**New ECB Premises
Urban planning and architectural design competition**

**MINUTES OF THE JURY MEETING
ON 28/29 AUGUST 2003**

First phase of the Competition – Jury meeting held on 28 - 29 August 2003

Design 104

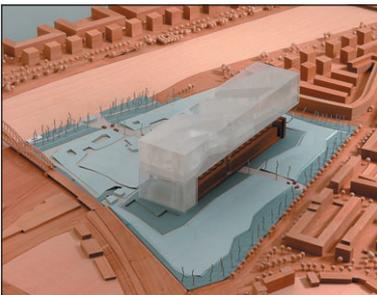
This outline concept was excluded due to non-compliance with the requirements of historical preservation. The fundamental appearance of the Grossmarkthalle is not respected. Furthermore, the Jury considered that the outline concept would not adequately reflect the ECB's values and would not convey the appropriate image. In addition, doubts were raised concerning the quality of the workplaces and the feasibility of the growth modules.

Design 108

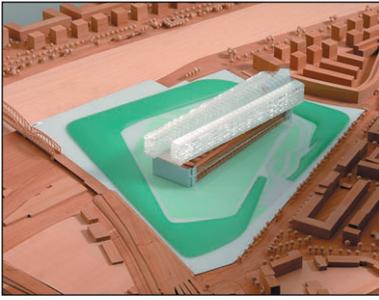
The Jury found this outline concept to be lacking in creativity. Furthermore, the Jury criticised the proximity of the slabs which limits views to the outside for some of the offices. The Jury also noted that the outline concept did not respect the height requirements and had deficiencies with respect to security requirements (stand-off distances of growth modules) and building law.

Design 109

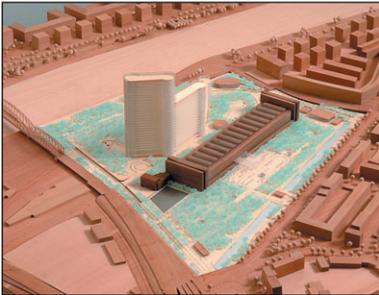
This outline concept was excluded due to non-compliance with the requirements of historical preservation in that the new premises overwhelms the Grossmarkthalle, taking away the autonomy and key characteristics of this monumental building. Furthermore, the Jury found that the concept would not reflect the ECB's values and would not convey the appropriate image. The feasibility of the extensions was called into question since they would create great construction challenges. The quality of workplaces was considered to be unsatisfactory as natural lighting and ventilation are reduced for the half of the offices that face the inner circulation corridor.

Design 112

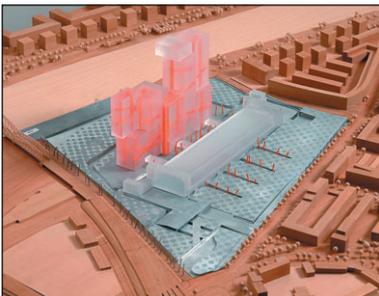
The Jury found this outline concept to be a conventional solution to an interesting and challenging programme, lacking in originality. The Jury could not see the interrelation between the new buildings and the surrounding area in particular the Grossmarkthalle. Furthermore, the singular connection between the new buildings and the Grossmarkthalle could result in circulation difficulties. Also, the Jury noted some deficiencies in the security requirements (western access not controlled, stand-off distances not respected).

Design 114

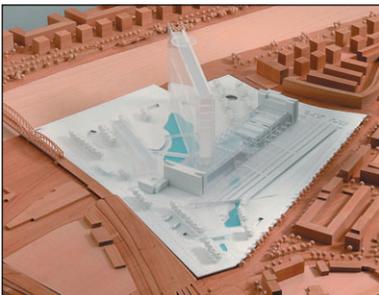
The Jury found the basic idea of the concept to be interesting, however the implementation of this idea was considered unconvincing and not able to reflect the ECB's values and would not convey the appropriate image. Furthermore, the office concept was found to be questionable due to the wasted space of open floor levels and a high amount of networking connections. These volumes appeared to be arbitrary with relation to their urban effect.

Design 130

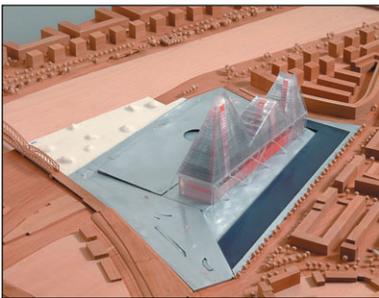
The positioning/location of the towers and their integration into the surrounding neighbourhood was considered an unsatisfactory solution from an urban planning perspective. The remoteness of the towers from one another causing long walking distances was also criticised. Furthermore, the floor plan was too small to allow a flexible and efficient office concept. In addition, the non-compliance with the statutory setback requirements was taken into consideration by the Jury.

Design 132

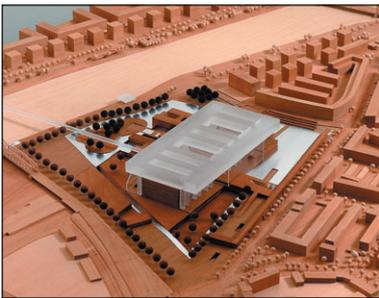
This outline concept was excluded due to non-compliance with the historical preservation requirements in that the new premises completely overwhelm and crush the Grossmarkthalle. The Jury found the proposed image for the ECB to be inappropriate. Furthermore, doubts were raised concerning the flexibility and quality of the workplaces; floor widths limit the possibility for natural lighting. Lastly, there was criticism regarding the insufficiencies of the landscape concept.

Design 136

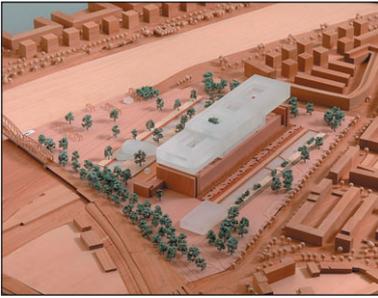
The Jury found the lack of interaction between the buildings and the integration of the whole ensemble into the surroundings to be unsatisfactory from an urban planning and architectural perspective. The non-compliance with the statutory setback requirements was also seen negatively by the Jury. Furthermore, the division between low-and high-rise buildings would create an undesired inequality in workplaces.

Design 148

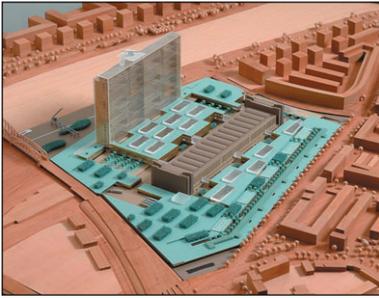
This outline concept was excluded due to non-compliance with the historical preservation requirements in that it would hide the fundamental appearance of the Grossmarkthalle. The Jury found the office concept to be unsatisfactory in particular because half of the workplaces face towards the inner courtyards. Additionally, there are long walking distances. Furthermore, the requested functionality and communicative approach for the office space were not considered.

Design 149

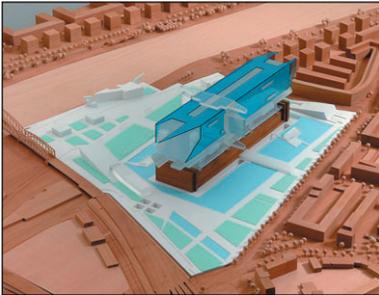
This outline concept was excluded by the Jury due to non-compliance with the urban planning goals for this area; the multi-storey base would create an edge/boundary to the city/surrounding neighbourhood. The Jury also found the access on the west side of the site to be problematic. Finally, the landscape and future insertion of the growth modules was seen critically as the entire site is built upon.

Design 151

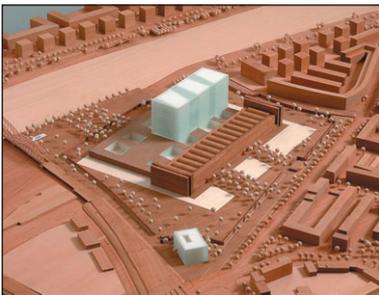
This outline concept was excluded due to non-compliance with the historical preservation requirements in that it would hide the fundamental appearance of the Grossmarkthalle. The Jury found the office concept to be unsatisfactory in particular because most of the offices have a relationship to inner courtyards rather than the outside. Additionally, the length of the corridors creates long walking distances.

Design 154

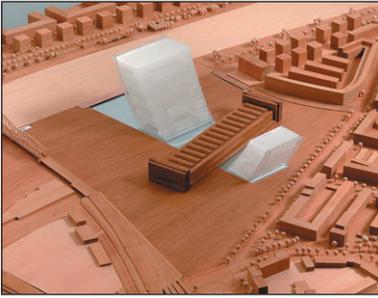
The connection between the new buildings and the Grossmarkthalle and the integration of the whole ensemble into the surroundings was considered to be unsatisfactory from an urban planning and architectural perspective. The Jury recognised the attention paid to a highly detailed security concept, however it would clearly separate the site from the urban surroundings. Additionally, the division between high- and low-rise building types creates an undesired inequality in workplaces.

Design 160

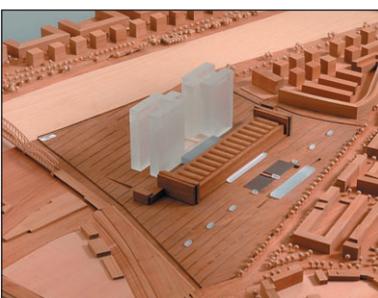
This outline concept was excluded by the Jury since it does not reflect the ECB's values and would not convey the appropriate image. Also, the outline concept did not comply with the requirements of historical preservation in that the new premises leans onto the Grossmarkthalle; the new slanted building overwhelms the Grossmarkthalle. Furthermore, the Jury raised doubts concerning the feasibility of the structure and of the growth modules, which would fill in the voids, used for "sky gardens". Lastly, the extensive use of water and landscaping was criticised by the Jury.

Design 162

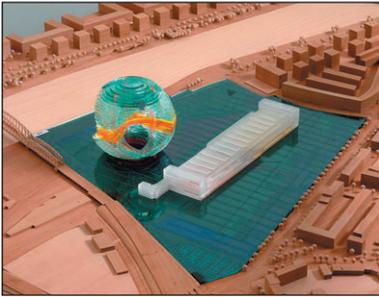
The connection between the new buildings and the Grossmarkthalle and the integration of the whole ensemble into the surroundings was considered to be unsatisfactory from an urban planning and architectural perspective. The Jury noted that the connection to the Grossmarkthalle through tunnels would create an unusable outside space. Furthermore, the quality of workplaces was seen to be questionable, as the middle zones have no contact to the outside and other areas only to inner courtyards. Lastly, the Jury did not consider the landscaping to be convincing.

Design 164

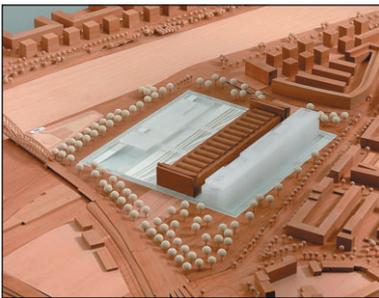
This outline concept was excluded by the Jury because it could not be successfully integrated into the surrounding neighbourhood. The Jury noted the lack of integration of the new premises with the growth modules and the Grossmarkthalle. Furthermore, it was noted that the inflexible form of the structure would not allow modifications. In addition, the Jury found the internal circulation to be questionable due to its disorienting nature.

Design 167

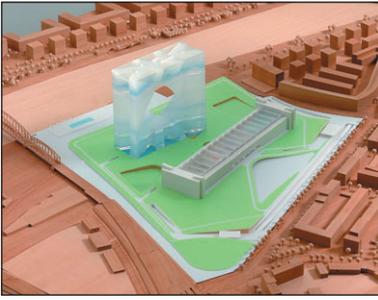
The connection between the new buildings and the Grossmarkthalle and the integration of the whole ensemble into the surroundings was considered to be unsatisfactory from an urban planning and architectural perspective; the separate elements of the Grossmarkthalle, new premises and growth modules are not integrated into a cohesive entity. The Jury called the growth modules into question, as they would hinder the views of the southern facing offices for the pre-existing building. Also, the quality of workplaces was criticised since the meeting areas could not be directly used on every floor.

Design 169

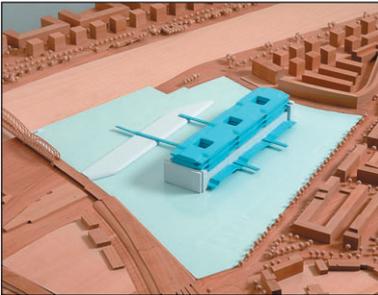
This outline concept was excluded by the Jury since it does not reflect the values for which the ECB stands and would not convey the appropriate image. Symbolically the institution would have no centre. Furthermore, the Jury criticised the concept for the extensions, which would call for a reduction in the grid and subsequent addition of more workplaces to each office floor. Finally, the internal circulation was criticised for the difficulties created by the central hole and the long walking distances from the main entrance to each workplace. Additionally, the Jury considered the floor plans to be less than optimal lacking the requested flexibility for the office concepts.

Design 111

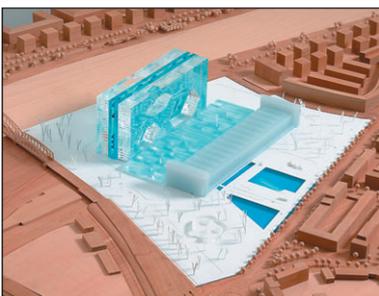
The Jury excluded this outline concept, since it does not reflect the values of the ECB and would not convey the appropriate image. Additionally, the rotating floor plan would limit the functionality of the office concept in terms of flexibility and reversibility. Furthermore, the growth modules were seen to be difficult to incorporate on top of the "energy lake".

Design 113

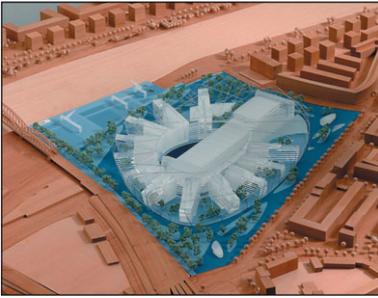
This outline concept was excluded by the Jury because it could not be successfully integrated into the surrounding neighbourhood; the new premises behind the Grossmarkthalle does not sensitively respond to the immediate area through its scale and form. The large voids would pose certain problems in the structure and internal circulation. Finally, the Jury noted that the growth modules were not integrated into the whole building ensemble.

Design 121

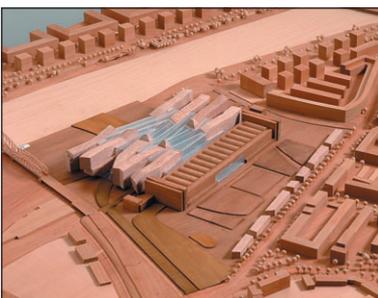
This outline concept was eliminated by the Jury due to the lack of information on the plans which was required at this stage. Information regarding the overall energy, landscape, security and access concepts was not available. In addition, doubts were raised concerning the quality of the workplaces; an unsatisfactory office layout would result in a lack of natural lighting for office floors facing interior courtyards. The growth modules would close in the buildings, limiting views to the outside.

Design 143

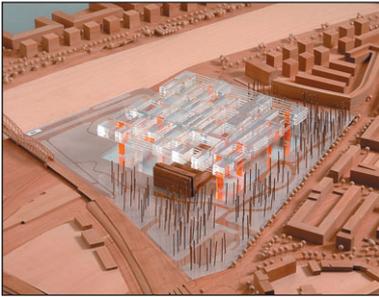
This outline concept was excluded by the Jury because it could not be successfully integrated into the surrounding neighbourhood, river and Grossmarkthalle. Furthermore, both the circulation on the site and internal circulation were criticised; the internal circulation suffers from lack of natural lighting and the separation of functions into different high-rises.

Design 122

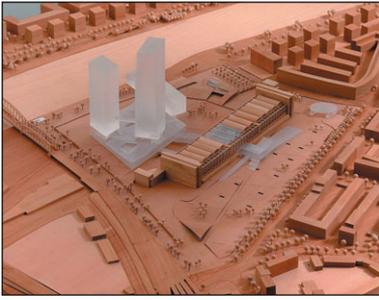
This outline concept was excluded due to non-compliance with the requirements of historical preservation; the appearance of the Grossmarkthalle would be dominated by the structure. Furthermore, the parking structure would hide the Grossmarkthalle from view. In addition, the growth modules were criticised, as they would be located on four levels below ground facing courtyards. Because many offices are located below ground or have large floor depth for offices above ground, many workplaces receive only minimal natural lighting. Thus, the quality of workplaces was seen to be questionable.

Design 107

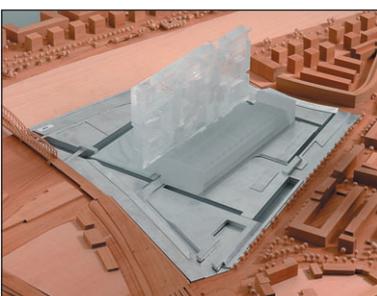
This concept was chosen by the Jury to continue into the second phase due to its sensitive solution, which considers construction related measures as well as innovative energy design solutions to ensure an appropriate and comfortable working environment. In addition, the growth modules seem to be well integrated into this concept. Furthermore, each workplace would have good views and proximity to communicative zones. Finally, the Jury noted that the outline concept allows for flexibility in the office floors of the towers.

Design 124

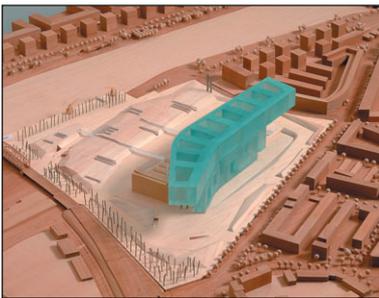
The Jury chose the outline concept to continue into the second phase as it integrates fully with the surrounding area. The new building is an object in dialogue with the Grossmarkthalle, which is to be preserved to its original status as far as possible. The interesting garden spaces throughout would create a high quality of working spaces as well as social spaces. The Jury also noted that the outline concept is extremely space efficient.

Design 140

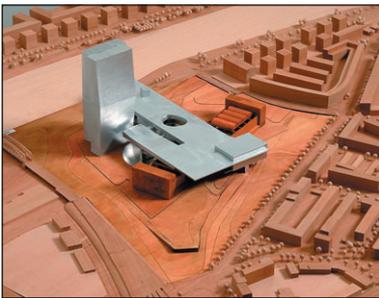
The Jury found that this outline concept should be admitted to the second phase because the hovering plane contrasts with the Grossmarkthalle without overwhelming this historical building. Also, the Grossmarkthalle would be well preserved. The concept would create an exhilarating effect with the shear buildings supporting the large mass above. The Jury noted that the office layout allows flexibility and reversibility and all required office types would be possible.

Design 152

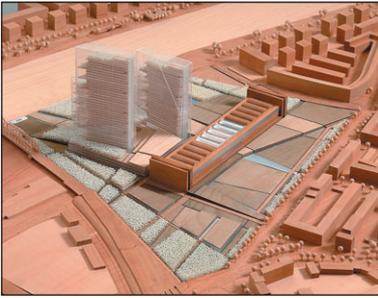
The Jury found that the original “village” concept for small-scale cluster buildings along the Main river was an original response to the given programme. The area between the buildings would be a nice social space. Furthermore, the outline concept allows the Grossmarkthalle to serve as the public facade of the ECB. Also, the green space on the site would carry into the building responding appropriately to the given requirements.

Design 163

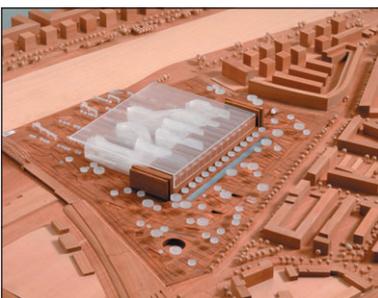
The Jury chose this outline concept to continue into the second phase because of the way the spaces relate to the human scale. The attention paid to the landscape was also seen as a successful approach to integrate the new premises with the Grossmarkthalle and the surrounding neighbourhood; the site is almost completely modelled with sloping planes and low hills. Furthermore, the Jury noted the positive quality of the office plan as most workplaces would receive natural lighting.
